# CITY OF MILWAUKIE

**File: #HR-2024-003**

**Site: 9712 SE Cambridge Ln**

## Historic Resource Land Use Review – Approval Criteria, Findings, and Recommendations 9712 SE Cambridge Lane, Milwaukie, Oregon

Sheet Title:  
 SOUTH  
 ELEVATIONS

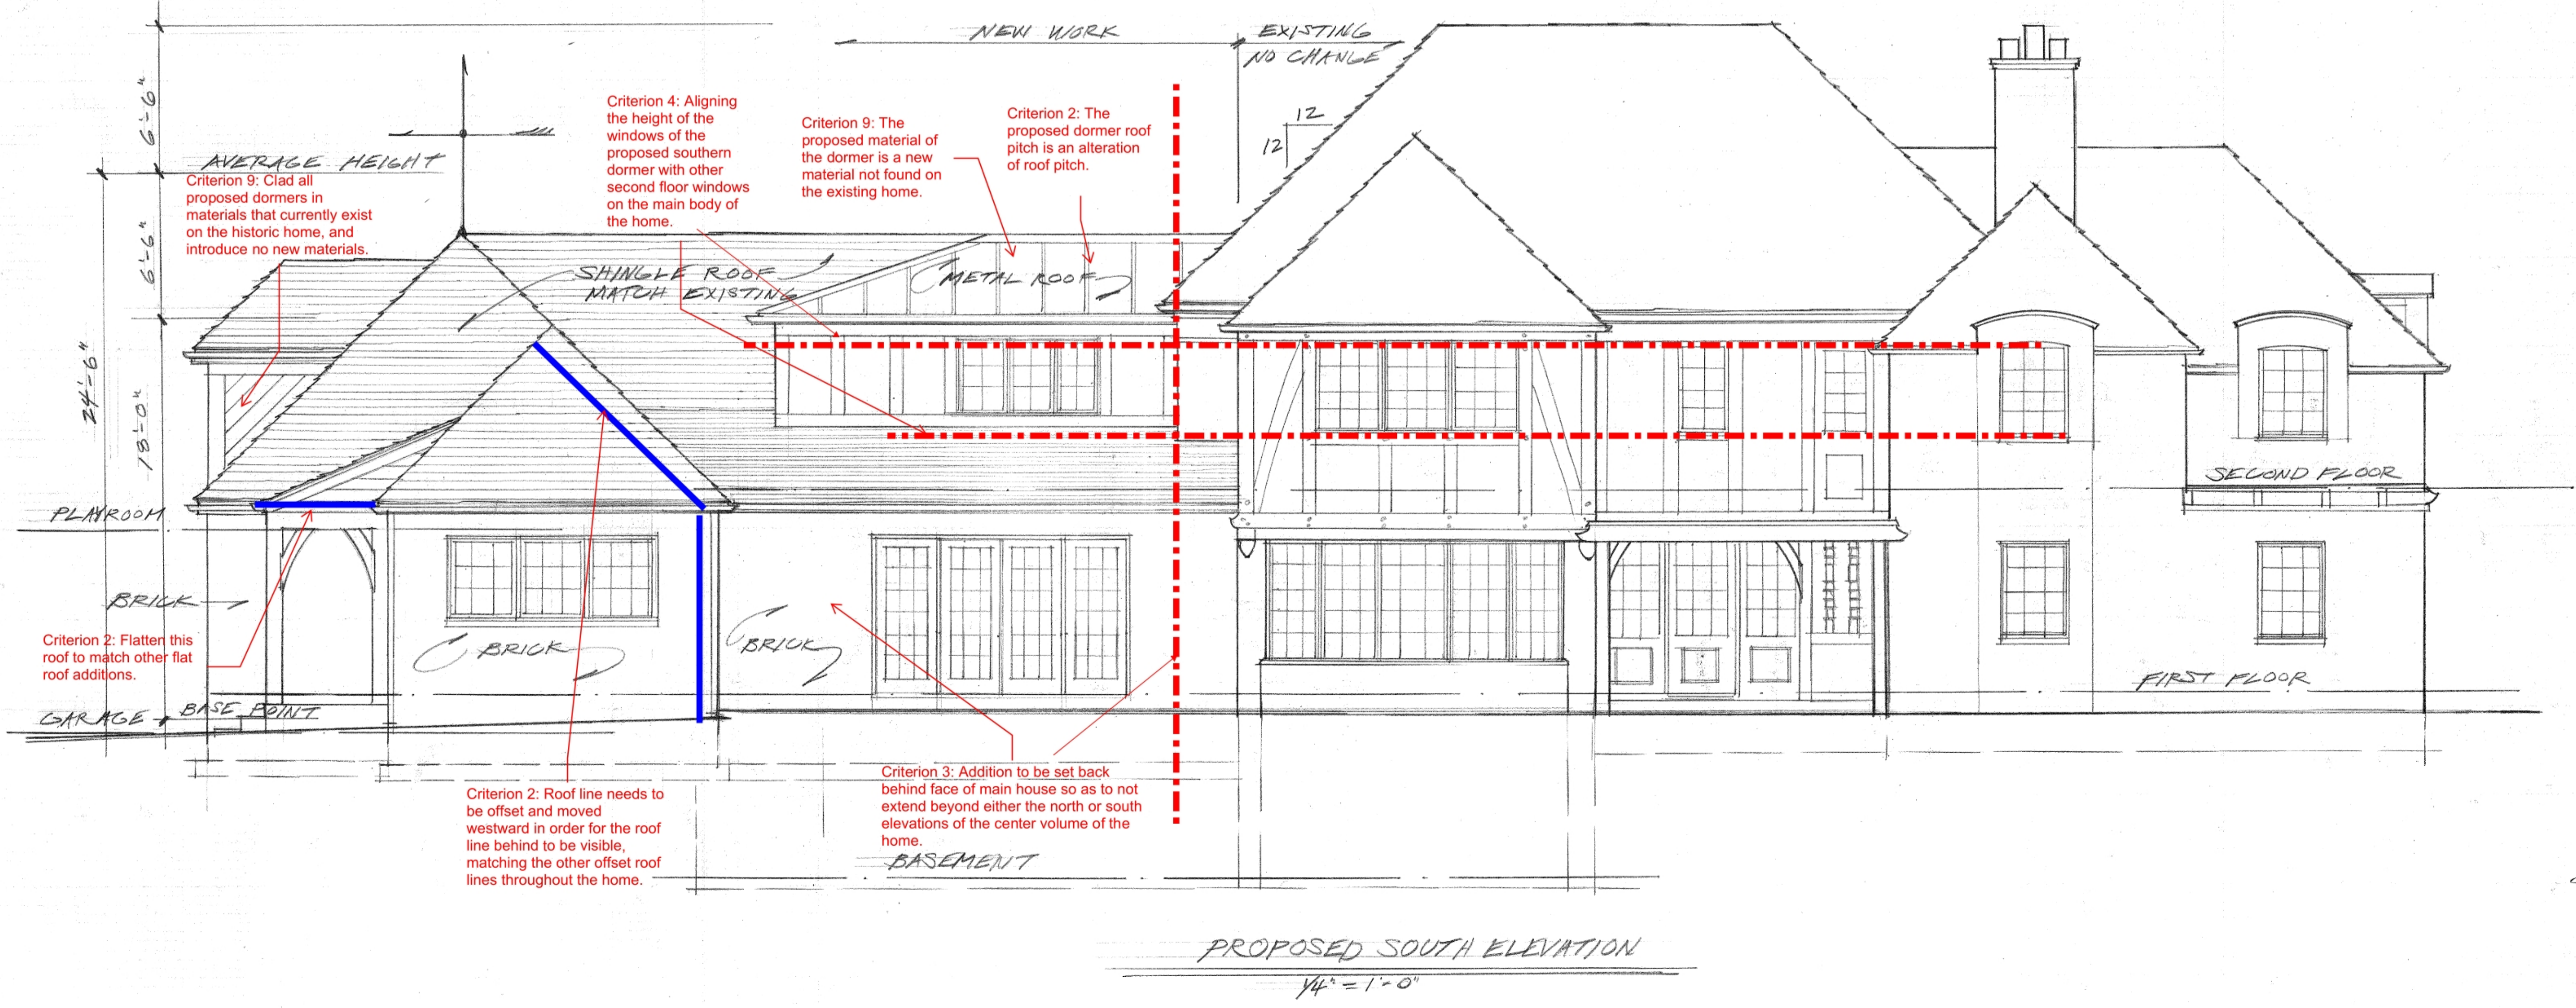
- Criterion 4: Aligning the height of the windows of the proposed southern dormer with other second floor windows on the main body of the home.
- Criterion 9: The proposed material of the dormer is a new material not found on the existing home.
- Criterion 2: The proposed dormer roof pitch is an alteration of roof pitch.
- Criterion 9: Clad all proposed dormers in materials that currently exist on the historic home, and introduce no new materials.
- Criterion 2: Flatten this roof to match other flat roof additions.
- Criterion 2: Roof line needs to be offset and moved westward in order for the roof line behind to be visible, matching the other offset roof lines throughout the home.
- Criterion 3: Addition to be set back behind face of main house so as to not extend beyond either the north or south elevations of the center volume of the home.

Sheet Title:  
 WEST  
 ELEVATION

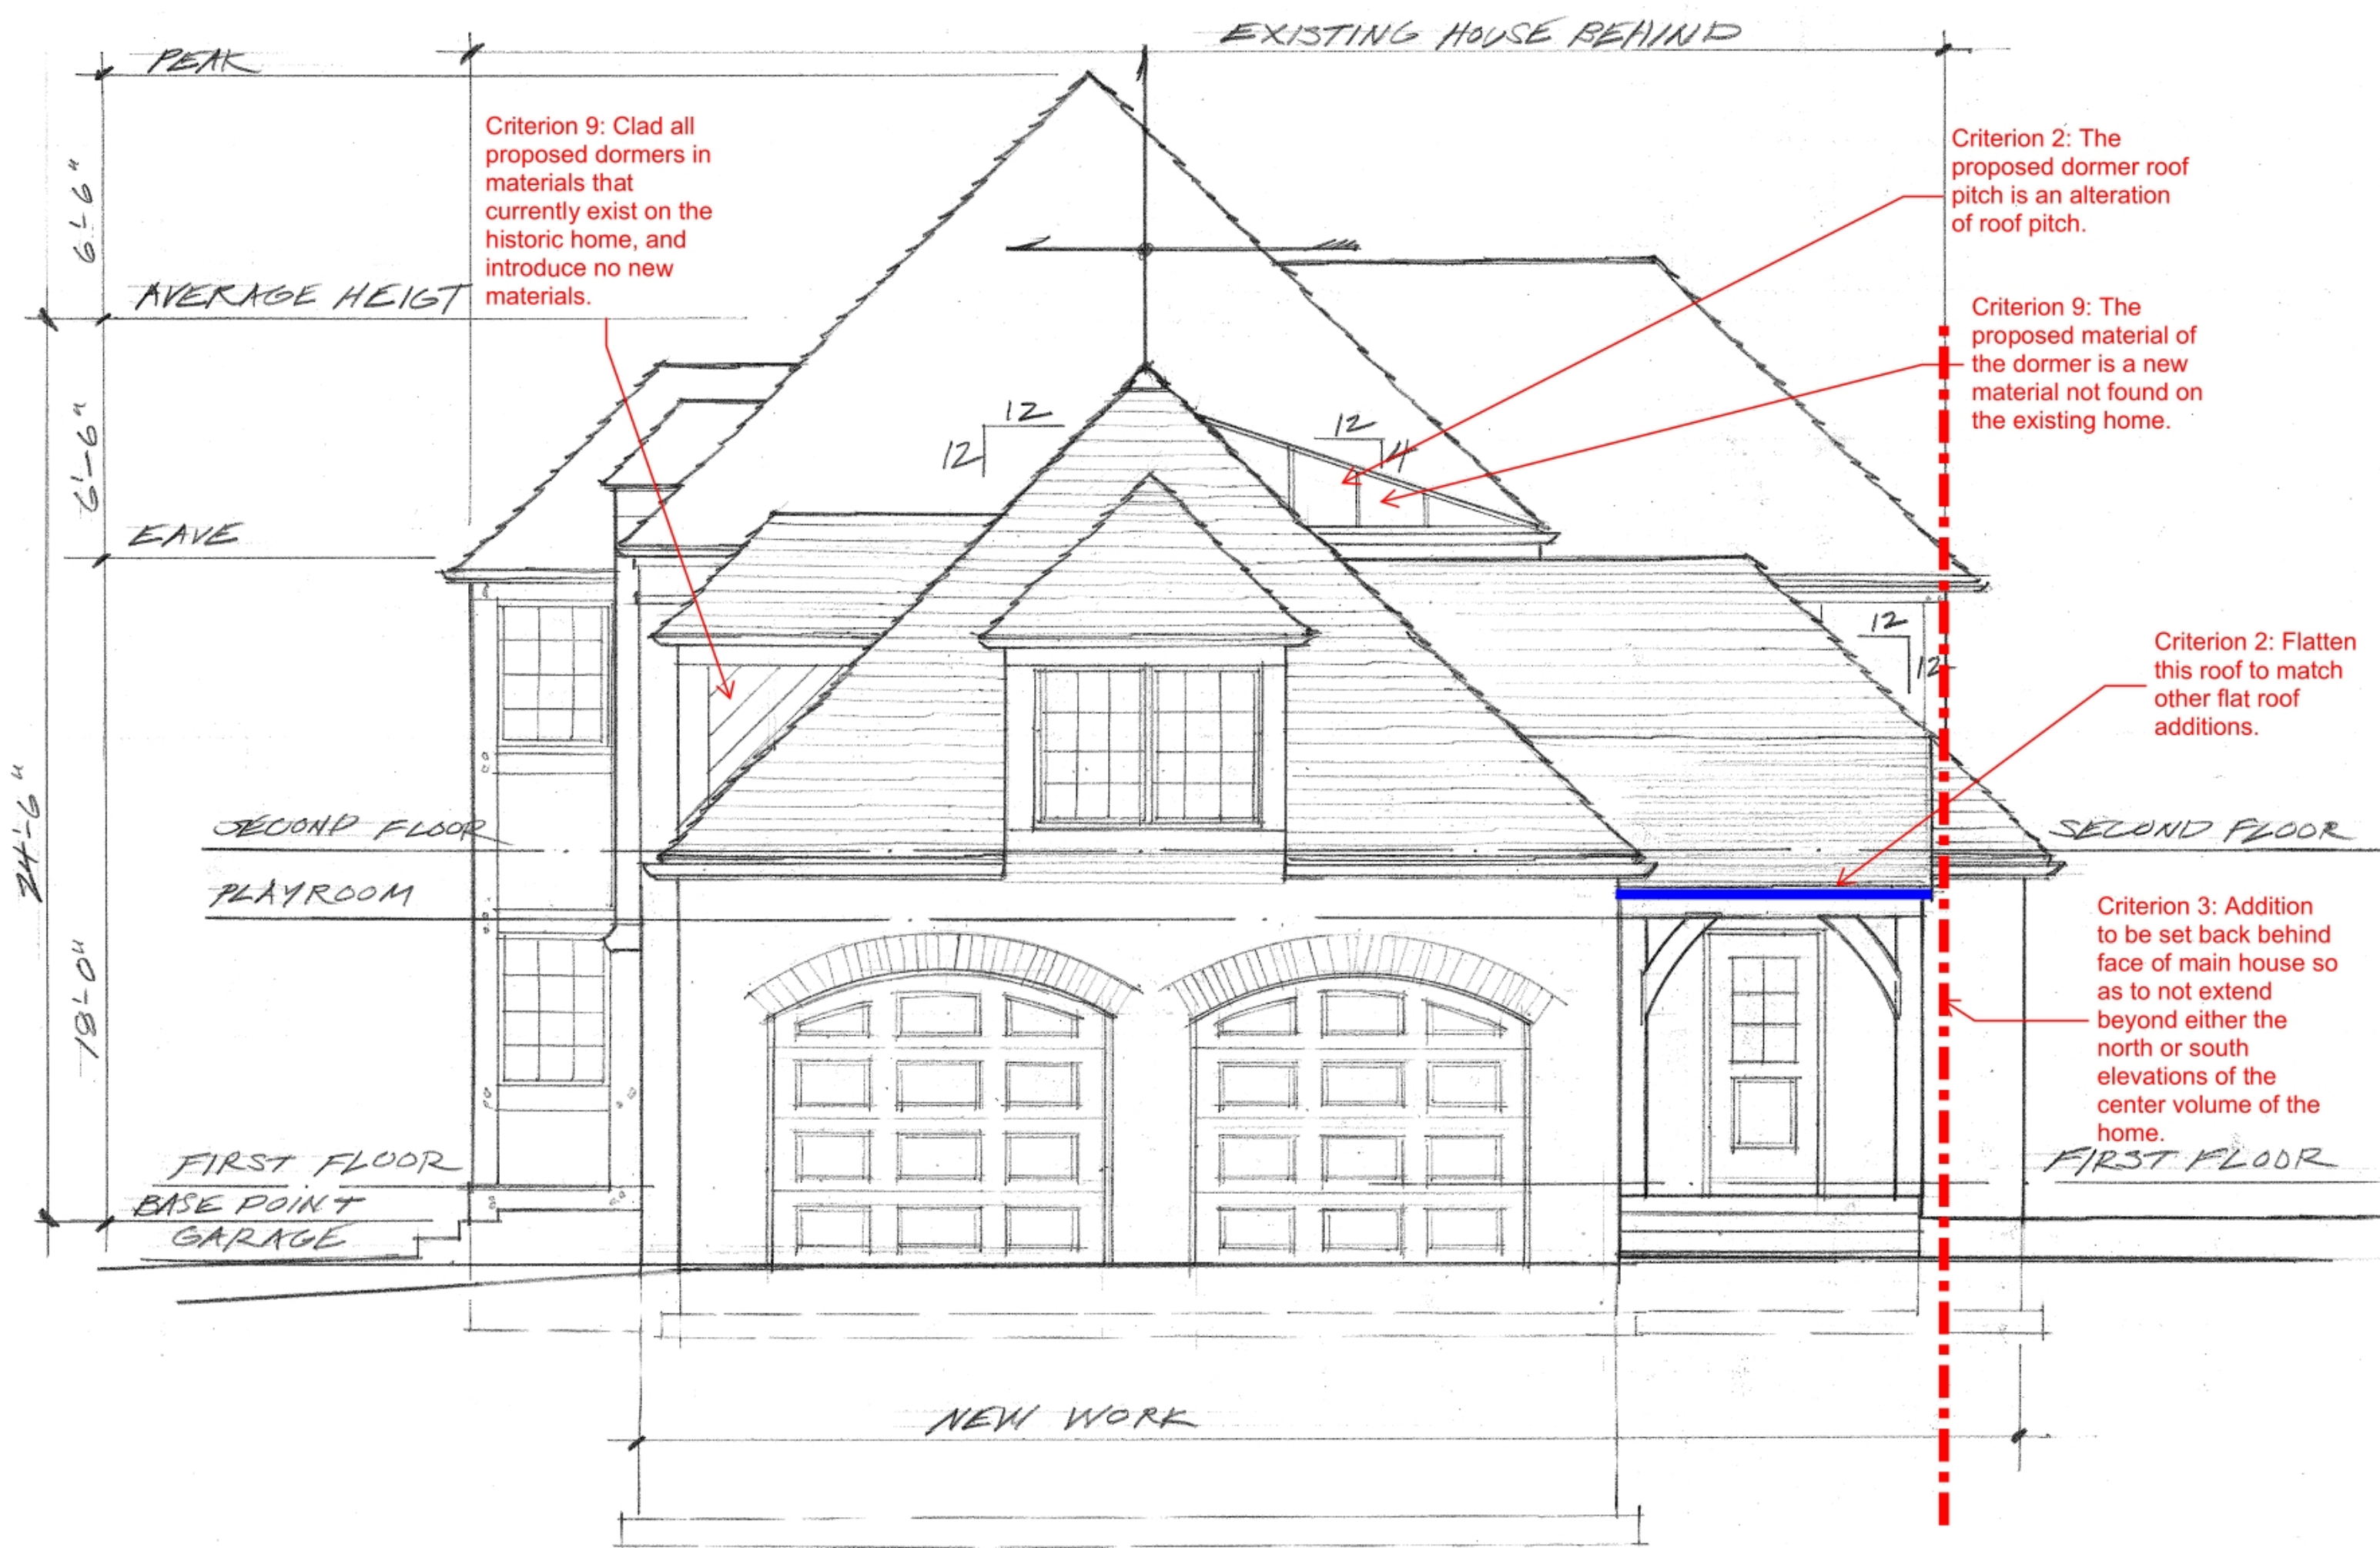
Criterion 2: The proposed dormer roof pitch is an alteration of roof pitch.

Criterion 9: The proposed material of the dormer is a new material not found on the existing home.

Criterion 2: Flatten this roof to match other flat roof additions.

Criterion 3: Addition to be set back behind face of main house so as to not extend beyond either the north or south elevations of the center volume of the home.

Criterion 9: Clad all proposed dormers in materials that currently exist on the historic home, and introduce no new materials.
